Memo

Development Assessment

Subject: Item 4.4 - DA2026/0390 - 16 Rabaul Road, North Curl Curl

Record Number: 2026/505906

Figure 1. Indicative future access pathway: arrows indicate driving in, reversing, then leaving in a forward direction. Underutilised space circled in red.

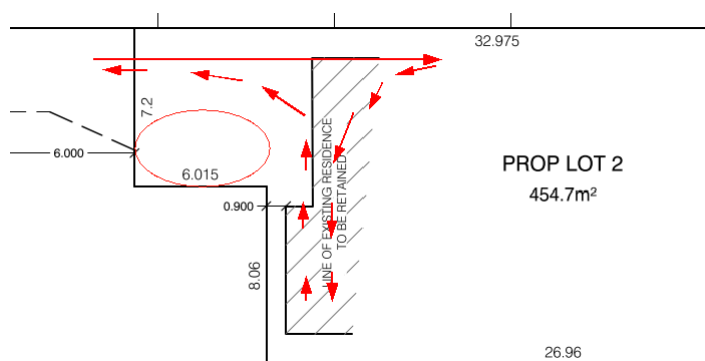
The proposed turntable is a direct consequence of the Applicant seeking to retain the existing dwelling whilst creating an undersized additional allotment. Whilst the turntable may provide a functional access solution in the short term, Council remains concerned about the long-term planning outcome that would result should Lot 2 be redeveloped in the future.

In that circumstance, the turntable would likely become redundant, leaving an irregular and underutilised portion of land that serves little planning purpose. The illustrated arrangement in Figure 1 demonstrates how a substantial area of the lot may become isolated from the future development pattern and contribute to an inefficient use of residential land.

The concern is not the visual appearance of the turntable itself, but rather what the turntable reveals about the subdivision design. Specifically, it demonstrates that the lot configuration has been shaped around retaining the existing dwelling rather than creating an orderly and enduring subdivision pattern.
